Subject: Partial Response to Environmental Protection Agency (EPA) May 20, 2004 Letter on CRA

Table 1 Summary Schedule for DOE Responses to EPA's First CRA Information Requests

Figure 1. CRA PA and CCA PAVT Spallings Release Means, All Replicates Pooled

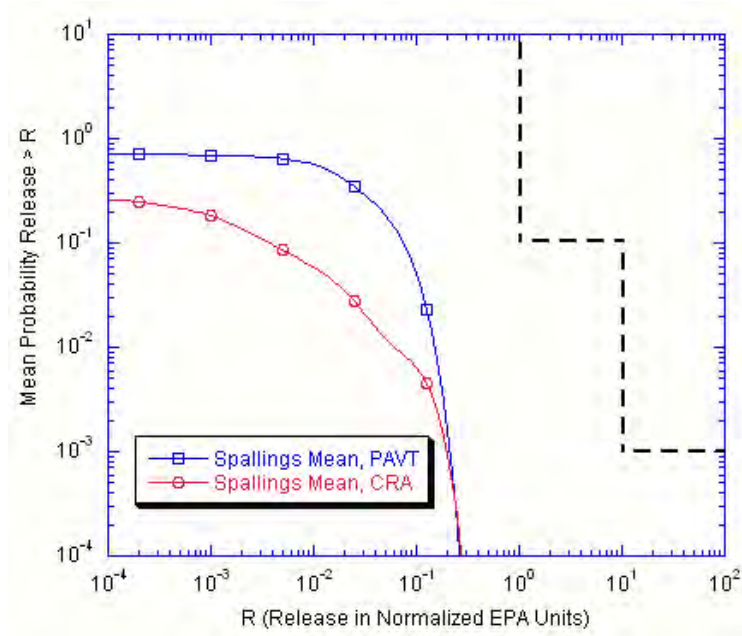
The previous baseline for DOE's compliance (from the initial certification decision completed in 1998) is the Performance Assessment Verification Test (PAVT) set of CCDFs and releases at the regulatory limits. To provide context for understanding the changes from the previous baseline, DOE must provide a comparison of the CCA PAVT results to the results of the CRA PA in a tabular form with columns/rows for 0.1 and 0.001 probabilities. For the table, use as an example the table submitted as part of the review of super compacted waste (Comparison of AMW and PAVT Results with CRA Results by C.W. Hansen, March 19, 2004. ERMS 534241 and EPA Docket A-98-49, Item II-B2-34).

The CRA PA releases at probabilities of 0.1 are smaller than the CCA PAVT releases at the same probabilities due to a decreased contribution of spall. The typical spall release in the CRA PA at a probability of 0.1 is smaller than the typical spall release in the PAVT CCA at the same probability (Figure 1).

Figure 1: Disturbed Rock Zone around a Raised Disposal Room in the Absence of Gas Generation (Park and Holland, 2003).

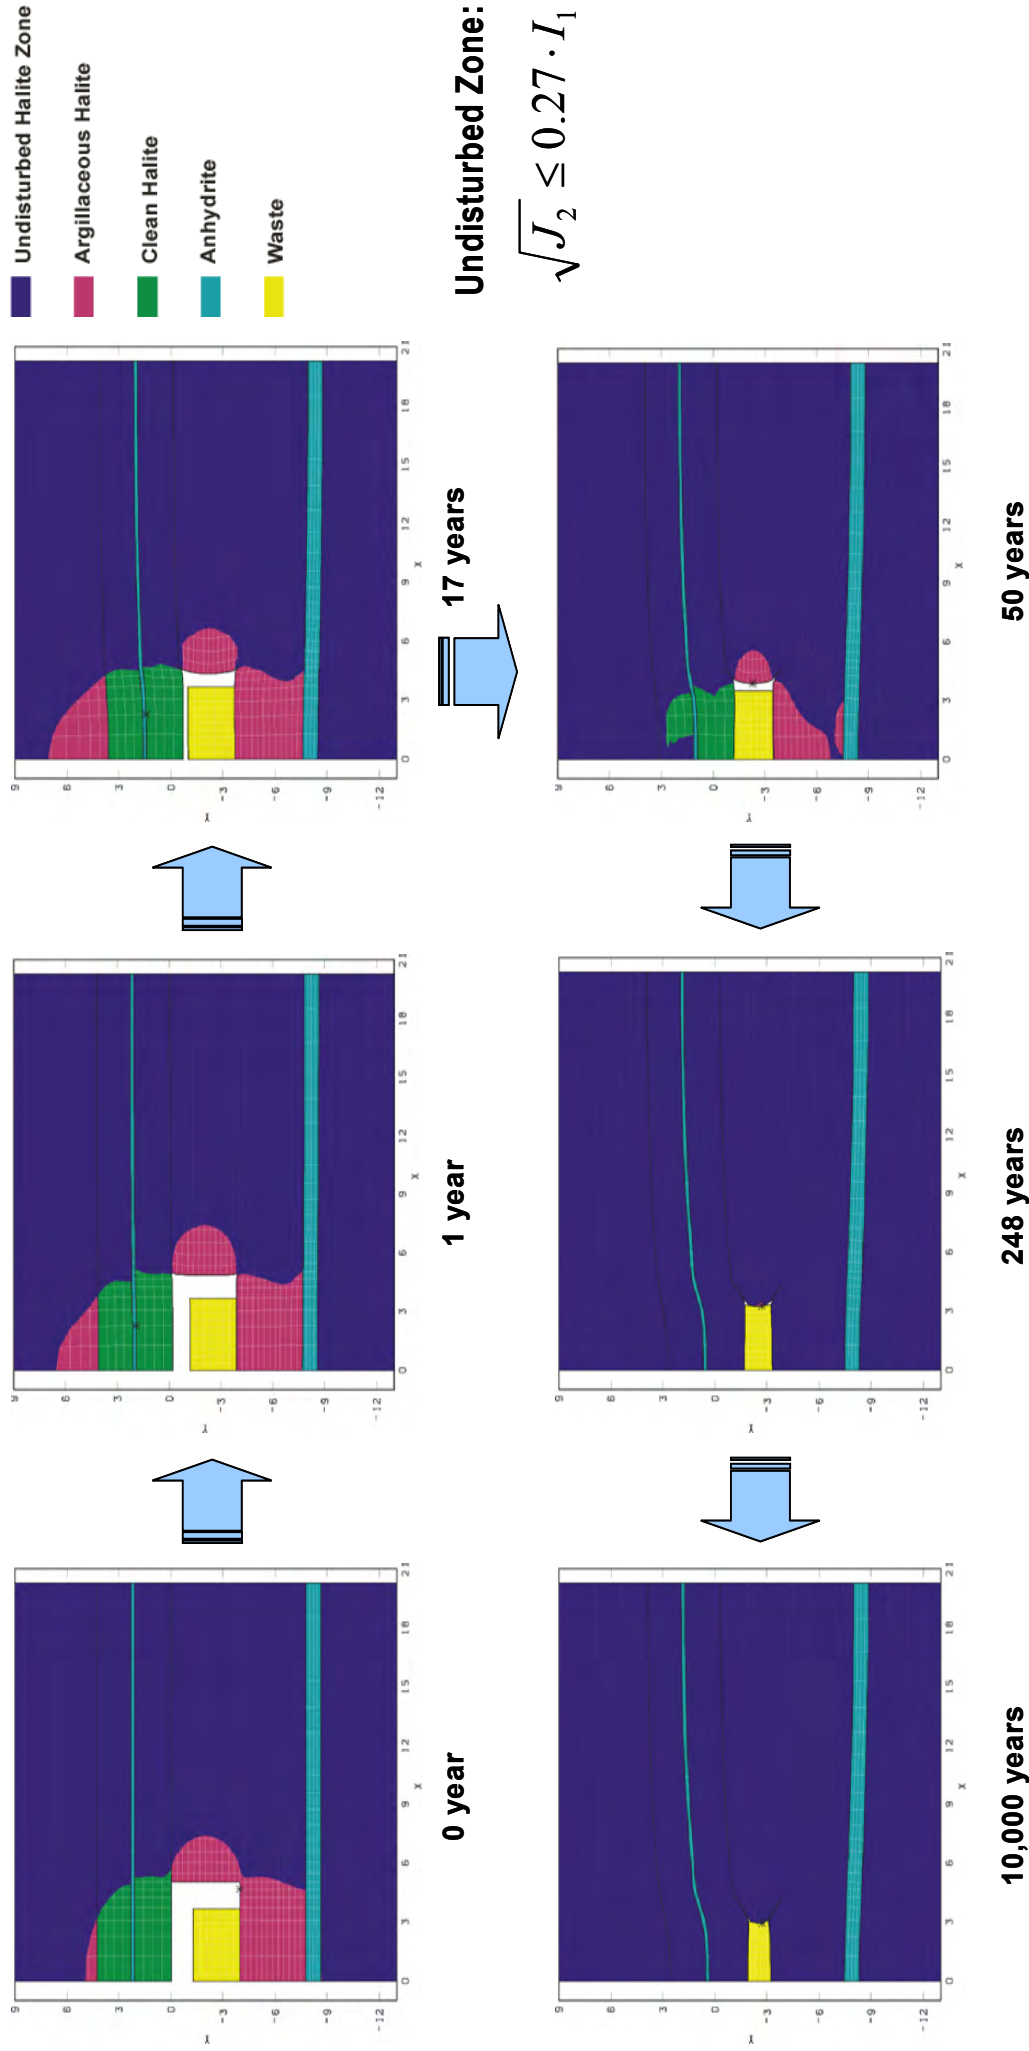
The CRA states that the "DRZ would not reach MB 138." DOE must supply documentation to justify this assertion.

Details of the Clay G analyses also provided insight to the local behavior of the DRZ evolution and devolution and the distortion of the anhydrite layers near the disposal rooms. An example of DRZ calculations is shown in Figure 1. These calculations at the raised horizon invoke principles of damage and healing as discussed by Hansen (2003). For the raised repository, the DRZ does not penetrate Marker Bed 139. The DRZ did penetrate Marker Bed 139 for the original horizon condition. The DRZ extends to its greatest dimensions in the period before the surrounding salt makes contact with the waste. Based on the modeling results, the maximal extent of the DRZ above the rooms is 6.5 m. The distance to MB 138 is 12 m and 9.5 m for the normal repository horizon and the elevated horizon, respectively.

Between 10 and 20 years, the creeping salt will begin pushing against the waste stack, a condition that decreases the driving stress difference. Shortly thereafter the stresses in the salt transcend from damaging to healing conditions. There is no time dependency applied to the healing process, because empirical evidence shows that healing would be rapid and the DRZ would diminish as depicted in Figure 1.

Thus, the geophysical testing and modeling results show that the DRZ is limited in extent and heals as the salt compresses the waste. Therefore, the DRZ would not reach MB 138.
